S4.55 MODIFICATION

S4.55 MODIFICATIONS	
Change ID	Name
Ch-01	Courtyard wall moved into courtyard
Ch-02	Alfresco deck reshaped
Ch-03	New window to first floor bathroom (W29)
Ch-04	Western wall on first floor moved forward by 650mm & balcony removed
Ch-05	New window to ground floor Dining (W20)
Ch-06	W04 - Kitchen window size change
Ch-07	Skylights relocated from stairwell to hallway
Ch-08	Eastern balcony screen reduced in length
Ch-09	Cellar footprint revised to include sauna

S4.55 MODIFICATION		
project	1130 PITTWATER RD	
	COLLAROY	
drawing	COVER SHEET	
drawn	SM / PC	checked MA
date	09.02.24	scale @ A3
project no	2_23_10	drawing no D0000
		issue F

S4.55 MODIFICATION		
project	1130 PITTWATER RD	
drawing	COLLAROY	
drawn	SM / PC	checked MA
date	09.02.24	scale 1:100 @ A3
project no	2_23_10	drawing no D2103
issue	F

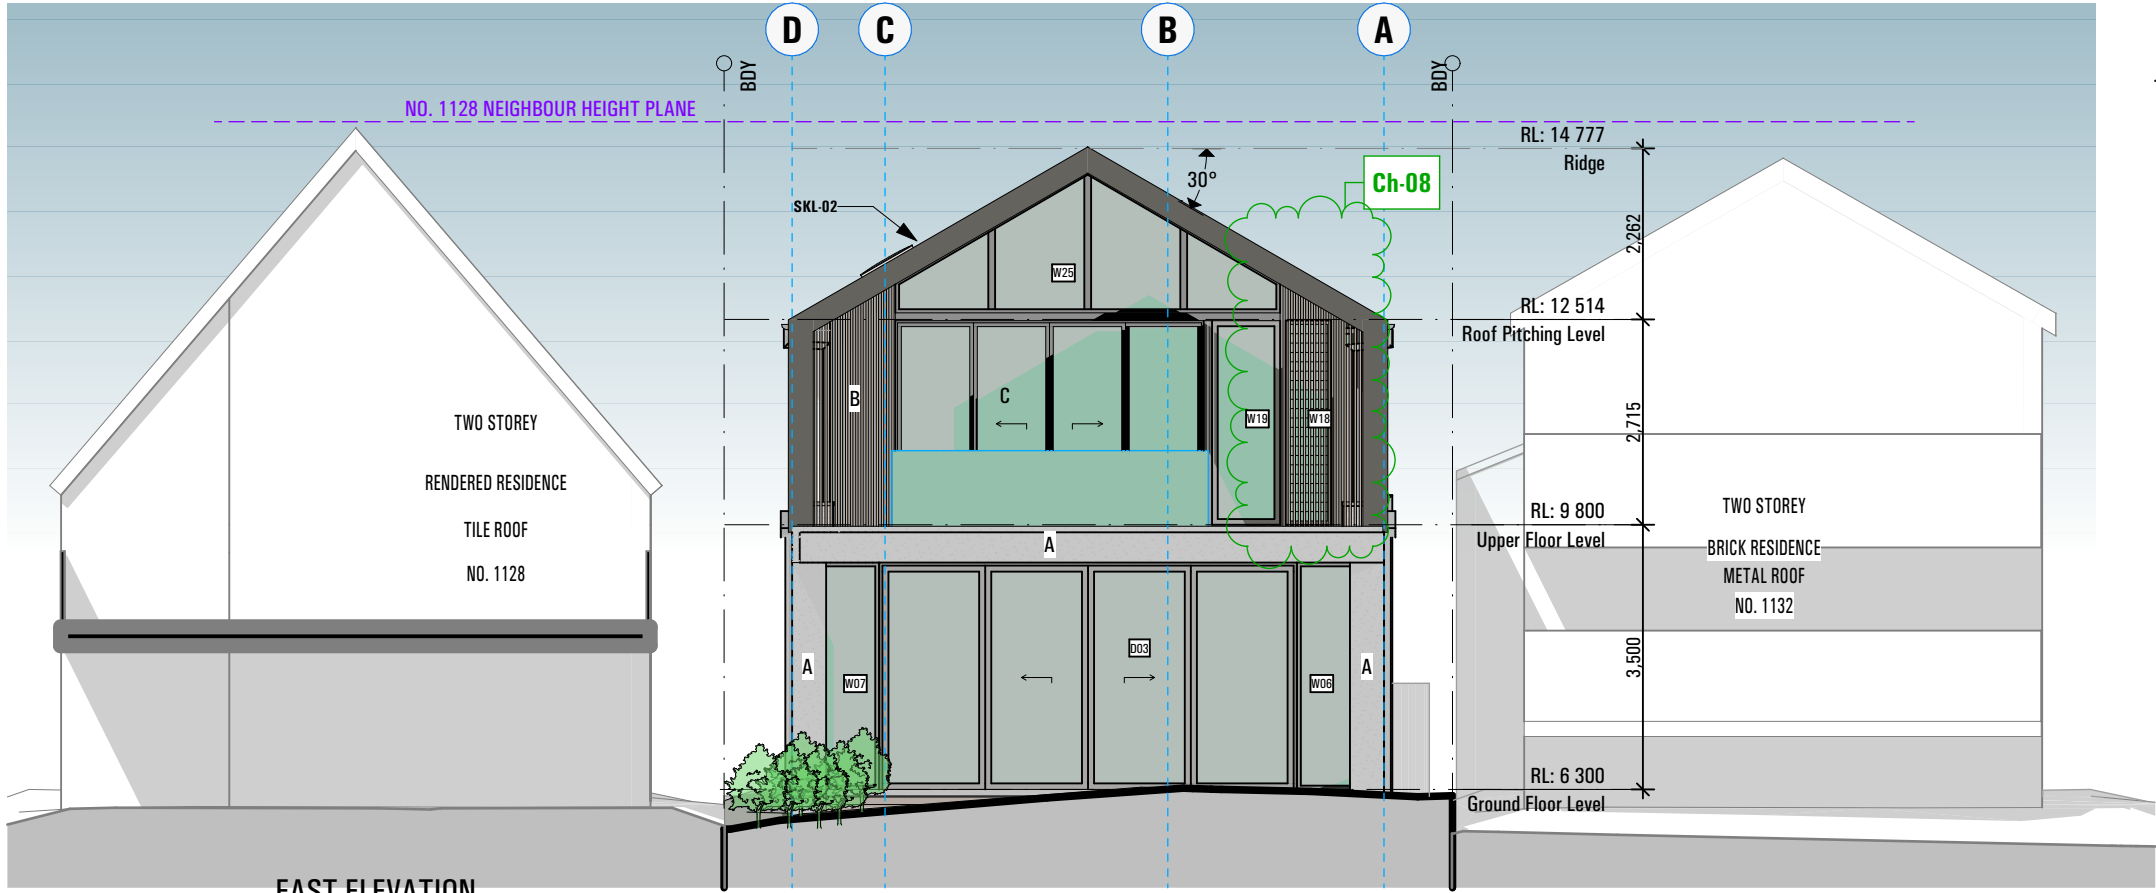
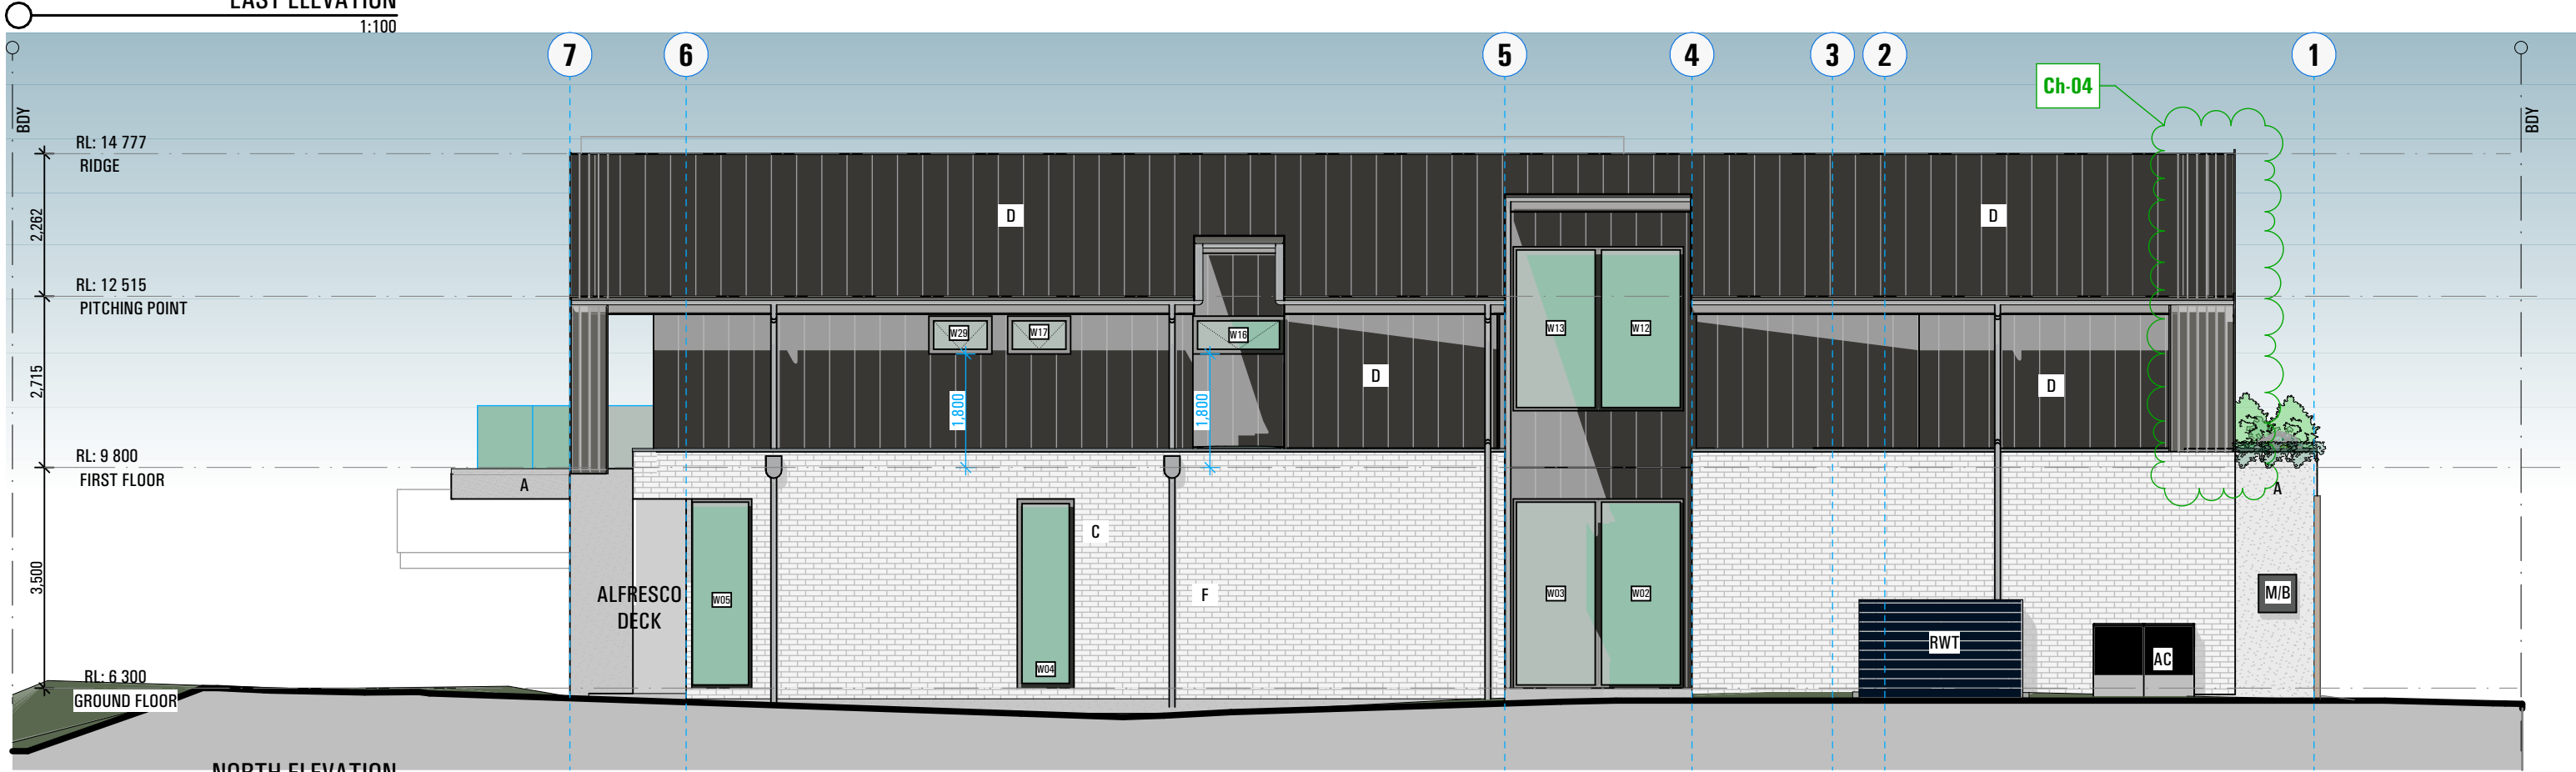
S4.55 MODIFICATIONS	
Change ID	Name
Ch-01	Courtyard wall moved into courtyard
Ch-02	Alfresco deck reshaped
Ch-03	New window to first floor bathroom (W29)
Ch-04	Western wall on first floor moved forward by 650mm & balcony removed
Ch-05	New window to ground floor Dining (W20)
Ch-06	W04 - Kitchen window size change
Ch-07	Skylights relocated from stairwell to hallway
Ch-08	Eastern balcony screen reduced in length
Ch-09	Cellar footprint revised to include sauna

S4.55 MODIFICATION		
project	1130 PITTWATER RD	
drawing	COLLARROY	
drawn	SM / PC	checked MA
date	09.02.24	scale 1:100 @ A3
project no	2_23_10	drawing no D3000
issue	F

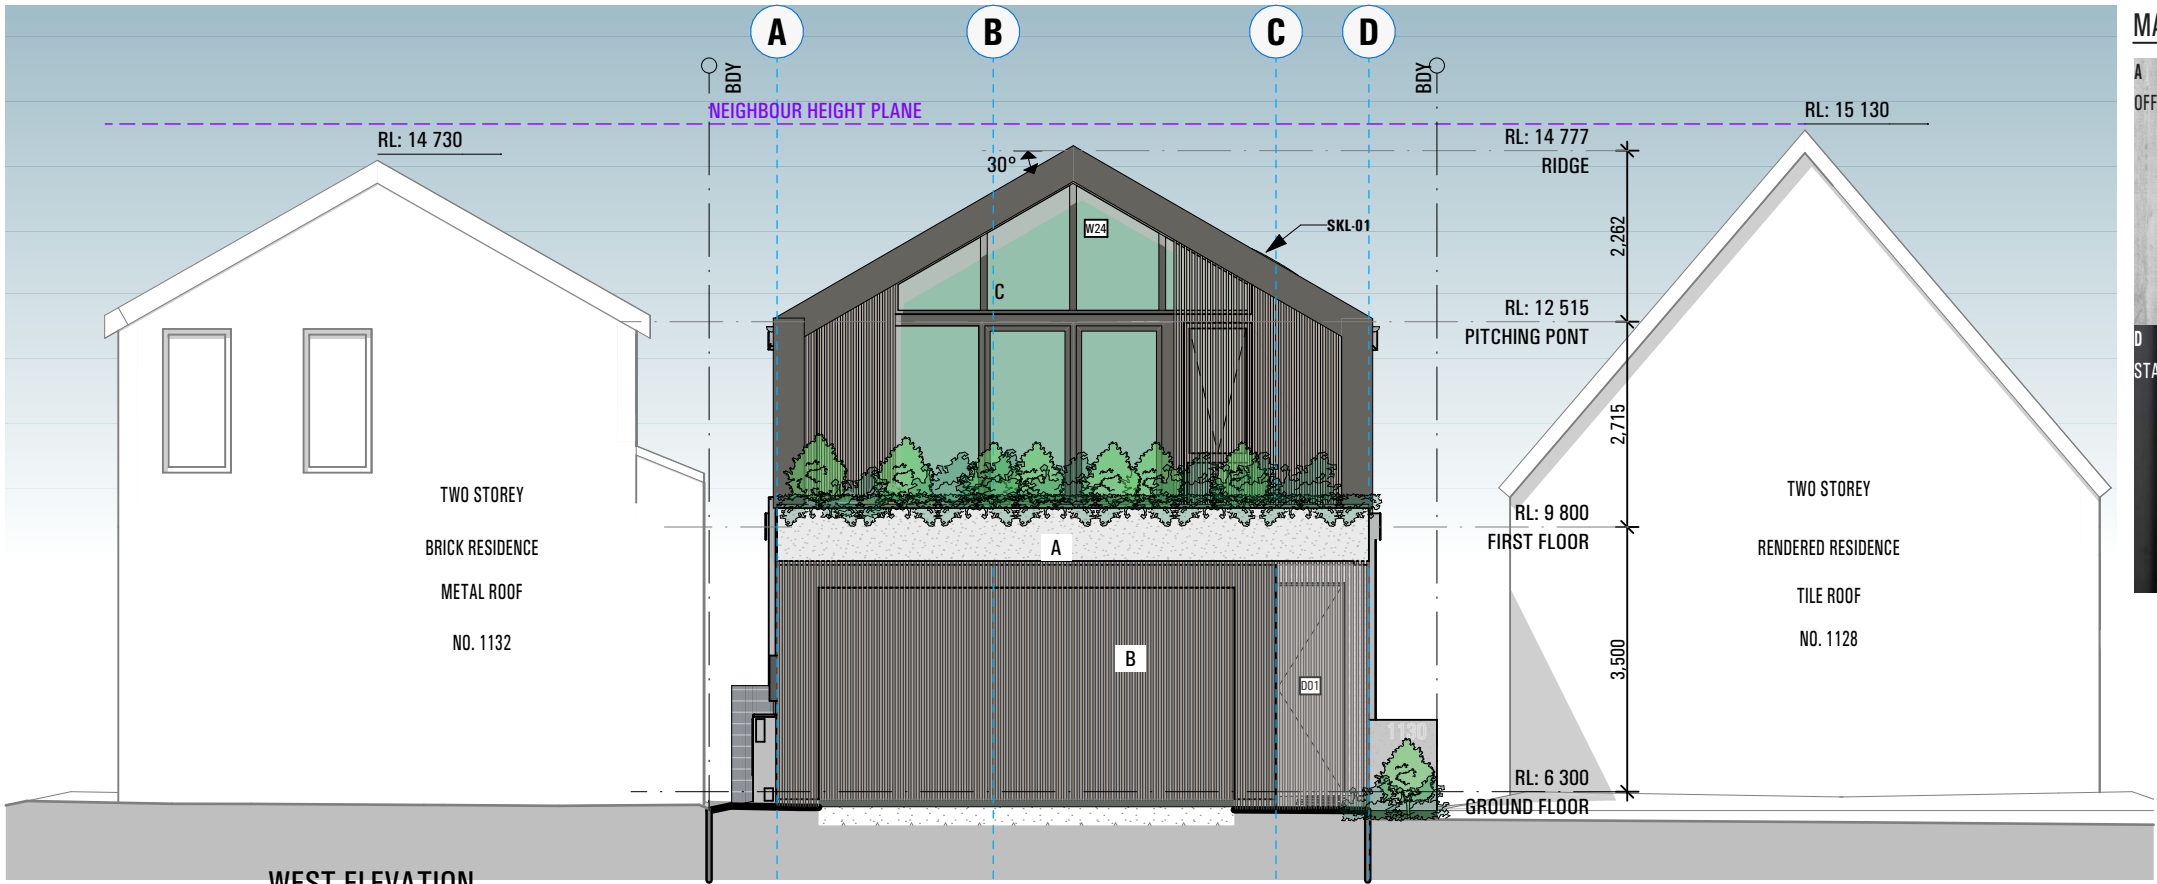
S4.55 MODIFICATIONS	
Change ID	Name
Ch-01	Courtyard wall moved into courtyard
Ch-02	Alfresco deck reshaped
Ch-03	New window to first floor bathroom (W29)
Ch-04	Western wall on first floor moved forward by 650mm & balcony removed
Ch-05	New window to ground floor Dining (W20)
Ch-06	W04 - Kitchen window size change
Ch-07	Skylights relocated from stairwell to hallway
Ch-08	Eastern balcony screen reduced in length
Ch-09	Cellar footprint revised to include sauna

S4.55 MODIFICATION		
project	1130 PITTWATER RD	
drawing	COLLARROY	
drawn	SM / PC	checked MA
date	09.02.24	scale 1:100 @ A3
project no	2_23_10	drawing no D3001
issue	F

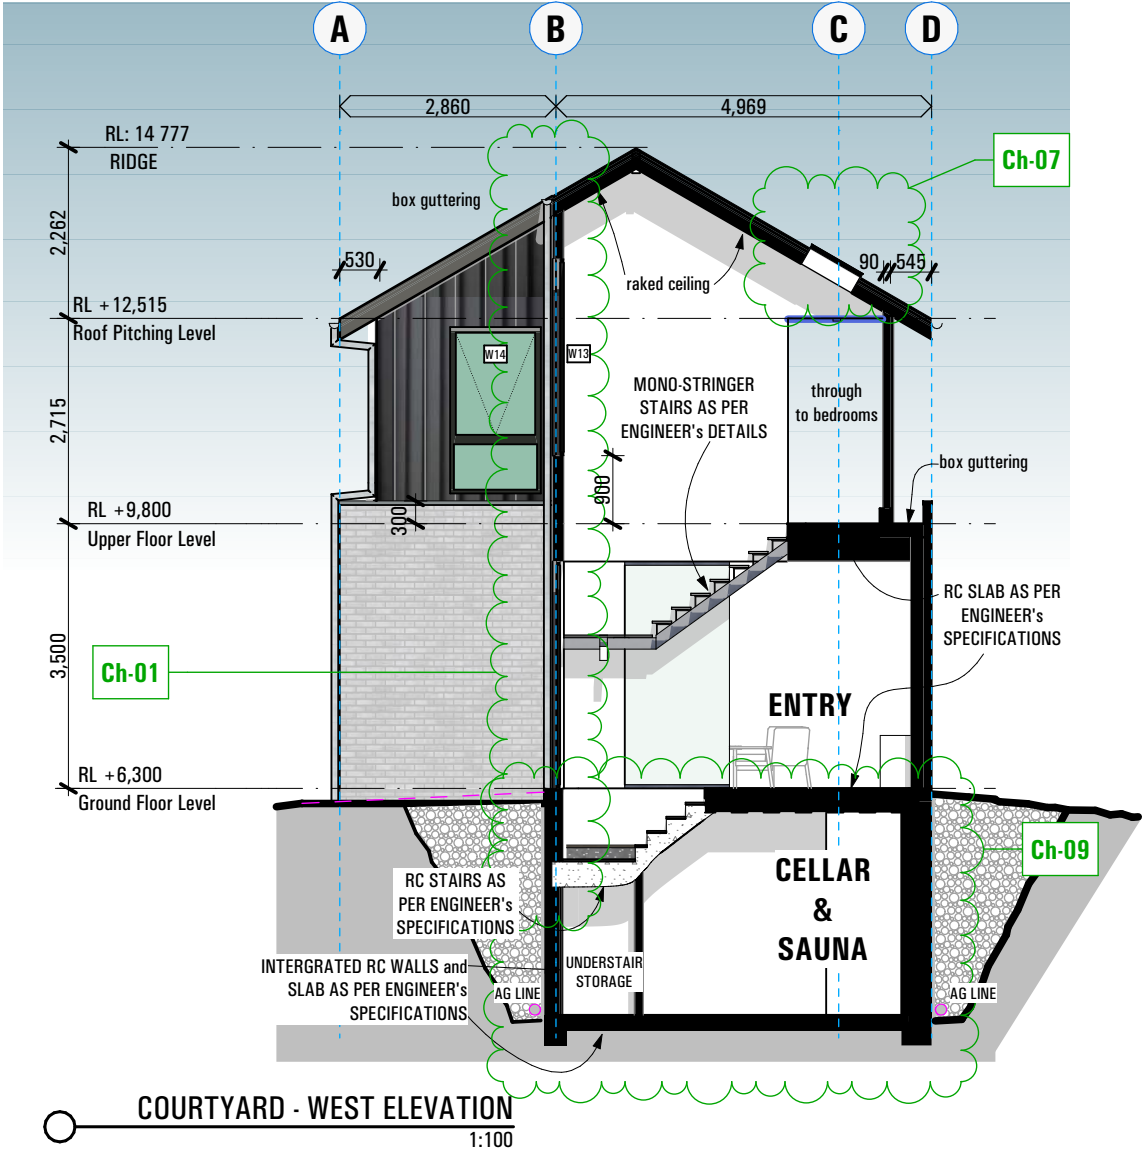
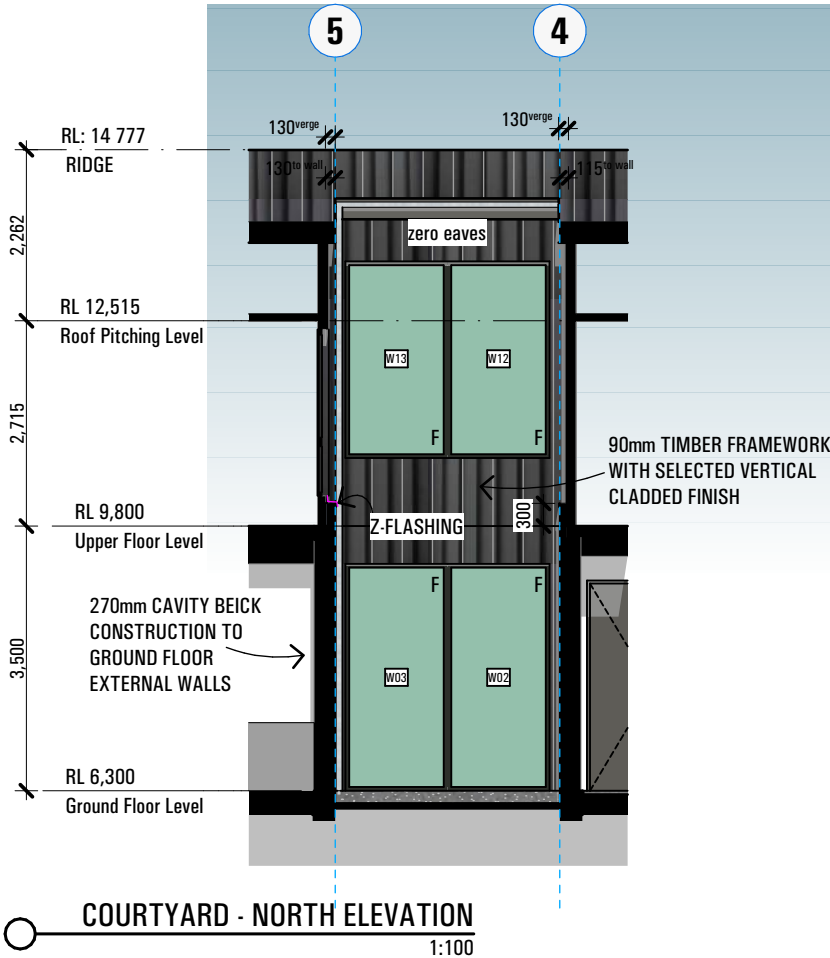
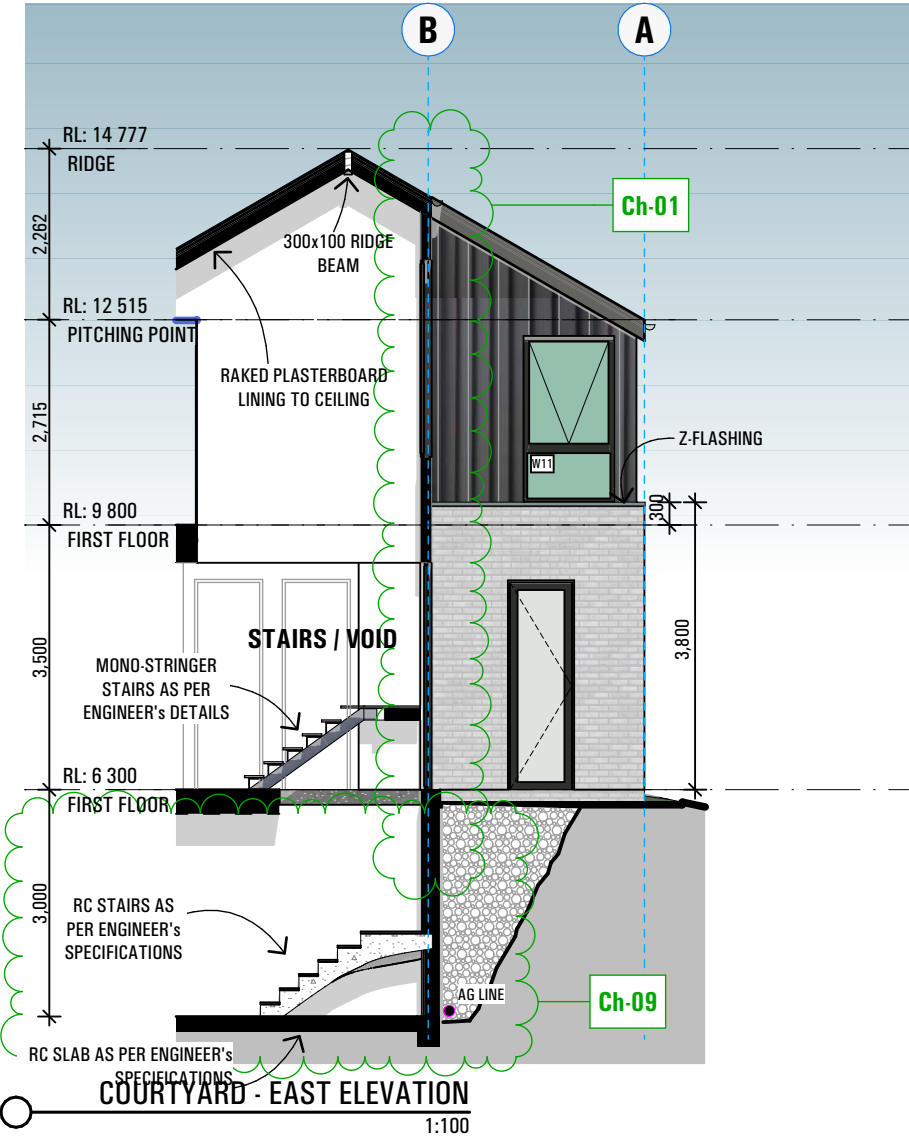
Change ID	Name
Ch-01	Courtyard wall moved into courtyard
Ch-02	Alfresco deck reshaped
Ch-03	New window to first floor bathroom (W29)
Ch-04	Western wall on first floor moved forward by 650mm & balcony removed
Ch-05	New window to ground floor Dining (W20)
Ch-06	W04 - Kitchen window size change
Ch-07	Skylights relocated from stairwell to hallway
Ch-08	Eastern balcony screen reduced in length
Ch-09	Cellar footprint revised to include sauna
